TOWN OF JEROME

AGENDA

Zoning Administrator Analysis Planning & Zoning Commission Tuesday, May 19, 2026

Zoning Administrator Analysis Planning & Zoning Commission

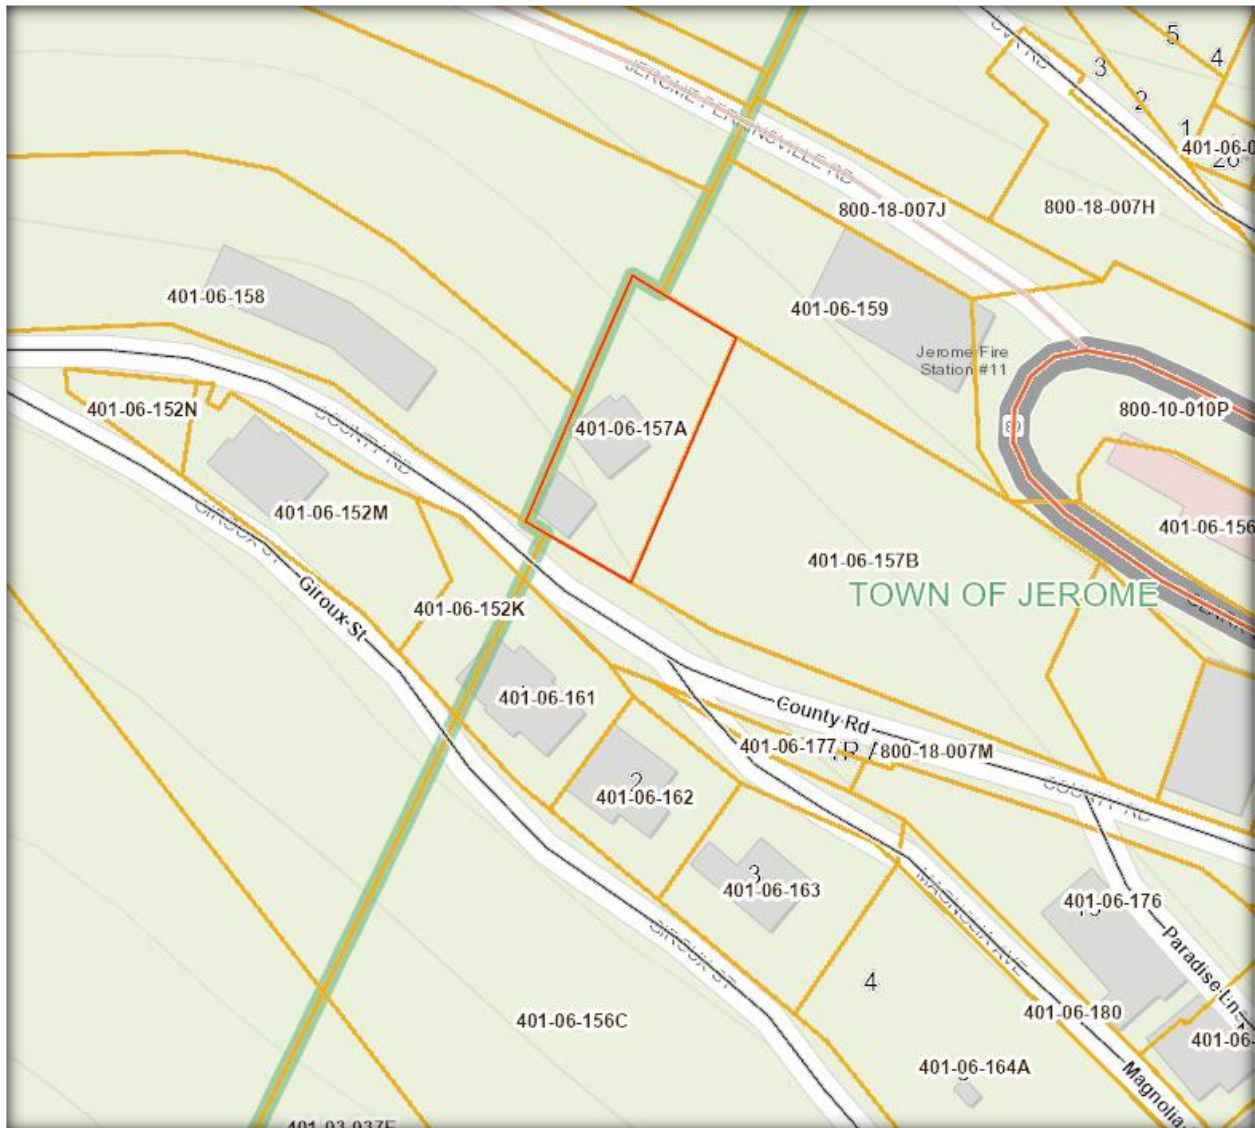
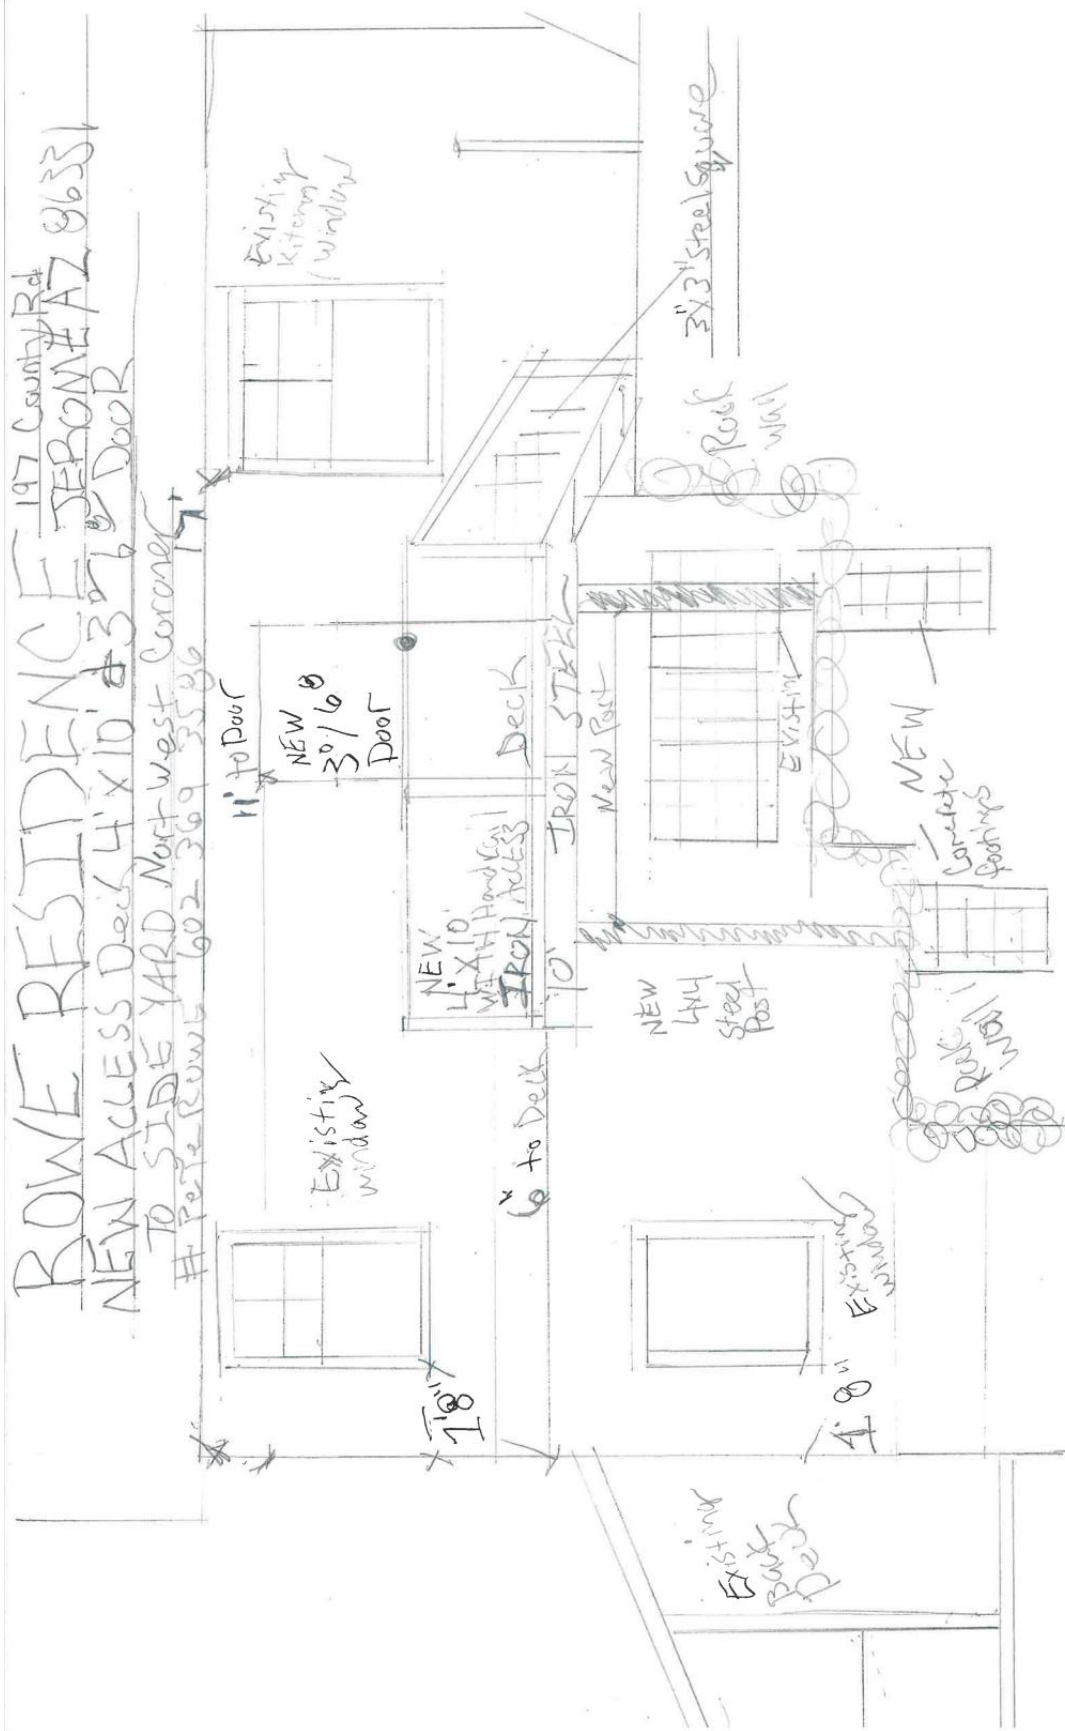
Background and Summary: The Applicant is requesting approval to add a new 4' x 10' steel beam deck and stairs in conjunction with a new door on the west side of the existing structure. This is intended to be another means of egress to the garden area below and along the side of the house.

Yard, Lot, and Area requirements in 502.H.10 (General Provisions) state that "No portion of any deck shall be located within (5) five feet of the lot line except in those districts where Residential use is not a permitted use. In those districts decks should conform to the required yard for that zone. Decks shall not encroach onto any public easement. Square footage of decks shall be included in lot coverage for each zoning district."

Lot Coverage standards for the AR zone in the Jerome Zoning Ordinance require that "Not more than (40) forty percent of the net area of the lot may be covered by the main building and all accessory buildings."

The proposed deck will not exist at a neat right-angle to the property line. The house is canted at about 45 degrees eastward from the property line to the west (as a datum, or "o" point). The deck is planned to be 4' wide which will bring the southwest corner close to the 5' setback limit but will not extend into the setback. The stairs and adjacent ground-level access will be improving the existing access situation should first responders be required to enter this area. The new doorway on this wall will also improve the egress from the building. As this is not a historic structure, there are no concerns as to a negative impact on existing historic buildings. All plans and information must meet code and pass inspection by the Town Building Inspector.

Property description information (left) and a site-plan showing the placement of the existing structure on the parcel.

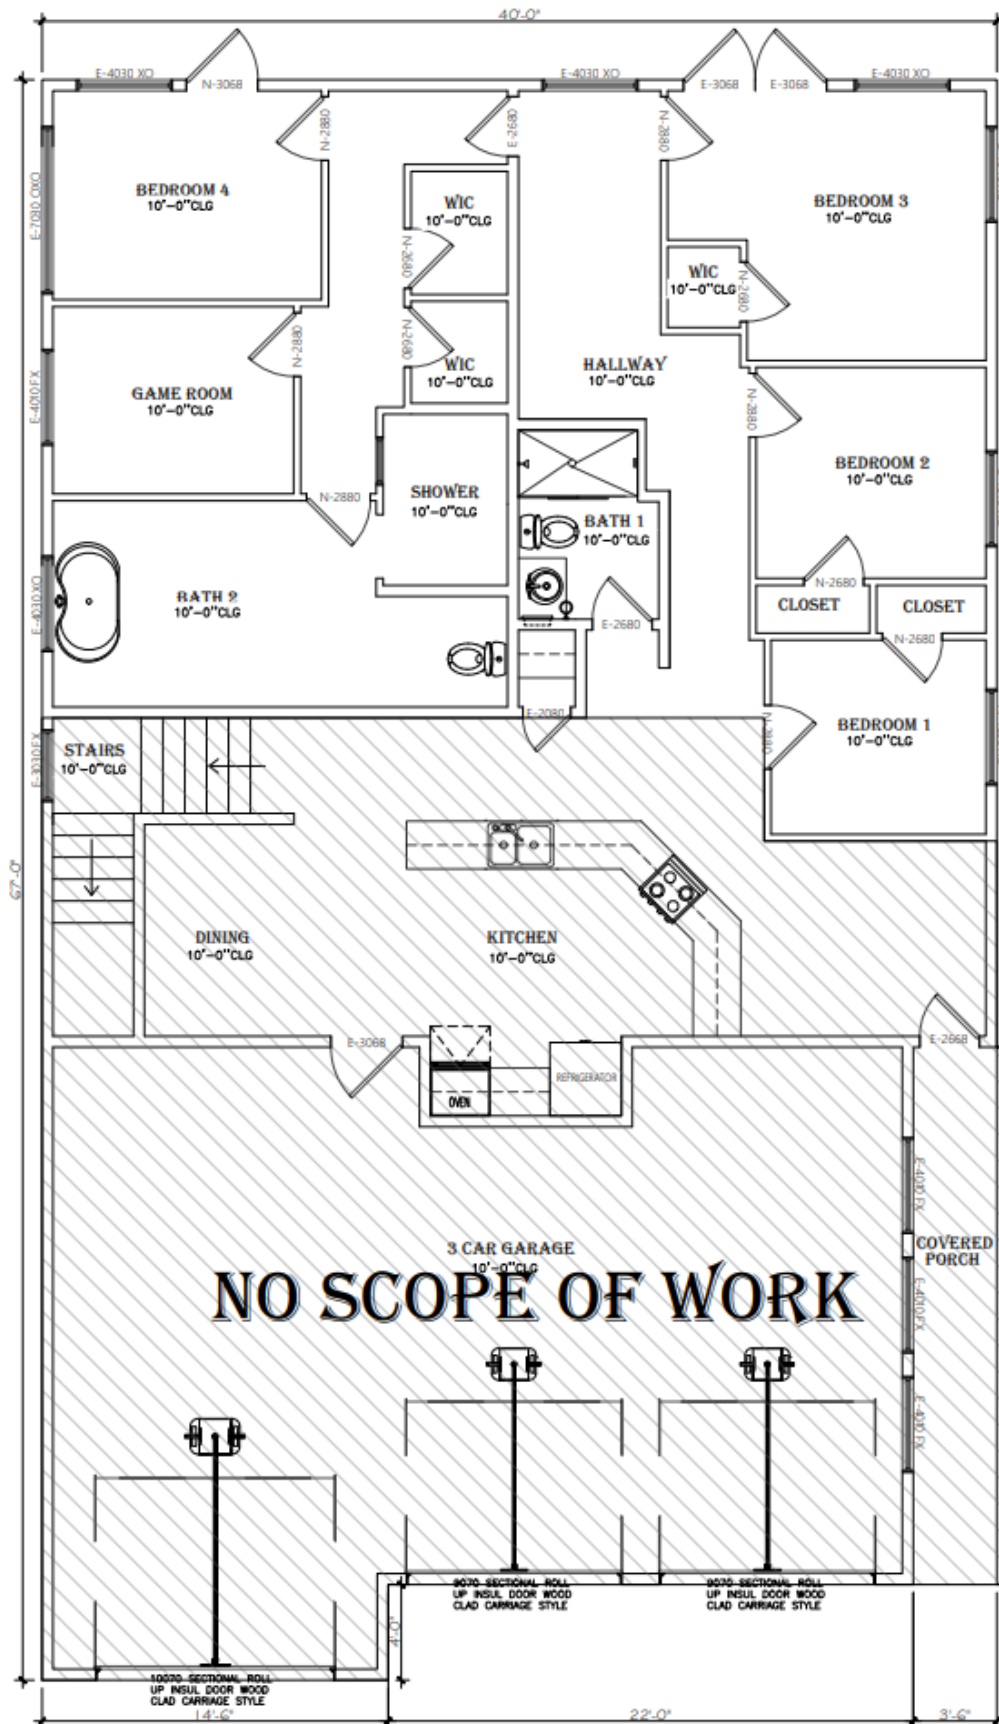
Response: The owner of 896 Hampshire, currently a 5-Bedroom single-family dwelling that is located within the R-2 Zoned strip of Hampshire. The owner desires to add 3 additional Bedrooms by removing the current living room area on the top floor. Each new Bedroom will require by code, a window that can act as emergency egress. The addition of three bedrooms would not increase the number of legal dwelling units as the required kitchen aspect that partly defines a dwelling unit is not changing, keeping the existing Single-Family use. The TOJ Zoning Ordinance does not place a limit or restriction upon the number of bedrooms within a dwelling unit. The regulations within the Ordinance limit the number of dwelling units allowed within a structure. This use is defined as:

Plan view of the proposed changes to the top floor, showing the removal of the living room in exchange for additional Bedrooms.

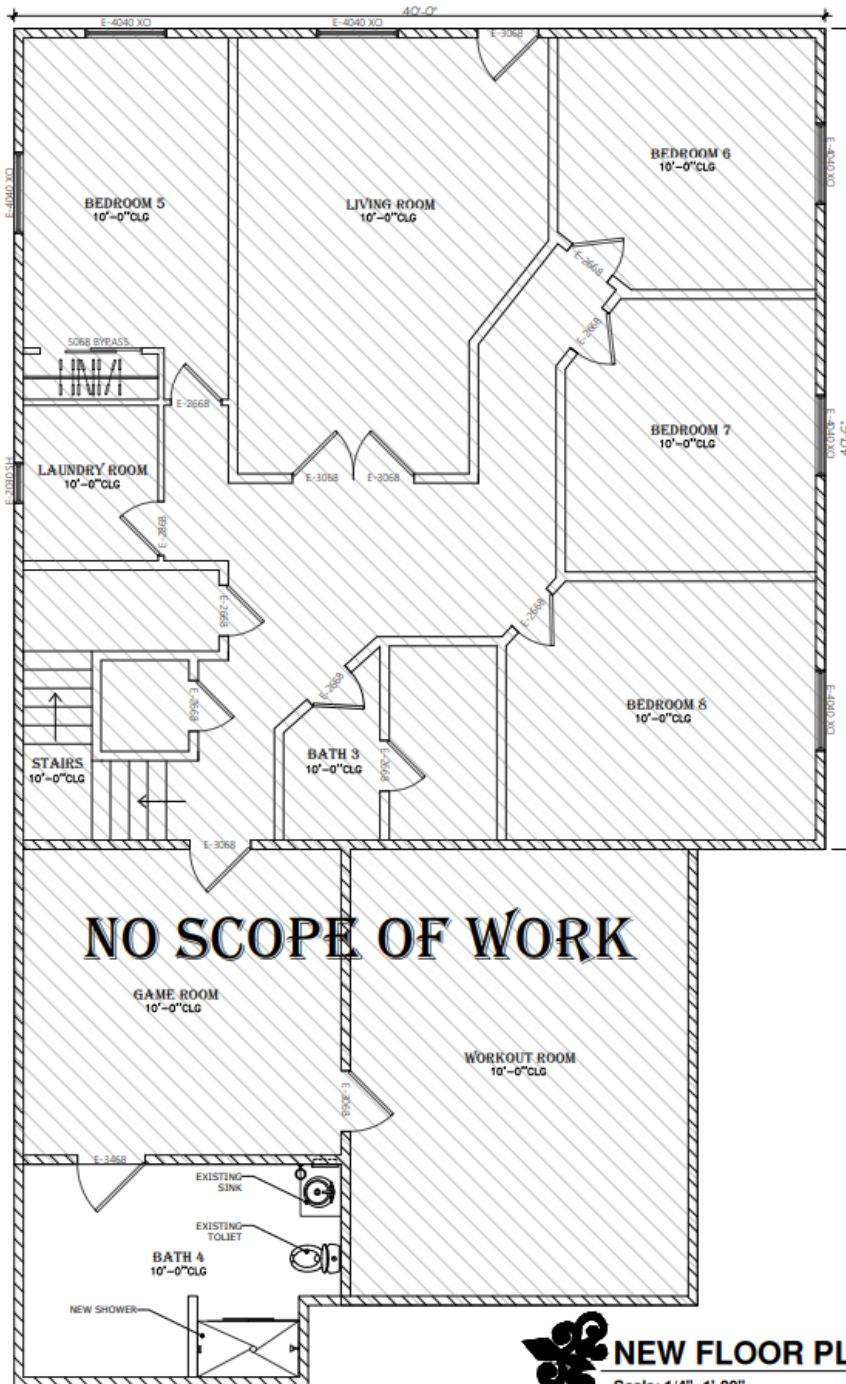
Background and Summary: The Applicant, Pathway Real Estate Investments LLC. Is requesting approval to add three bedrooms to the 5-bedroom single-family residence at 896 Hampshire. This would include the addition of windows that are required by code to serve as emergency egress. The drawing for these changes are provided within this analysis.
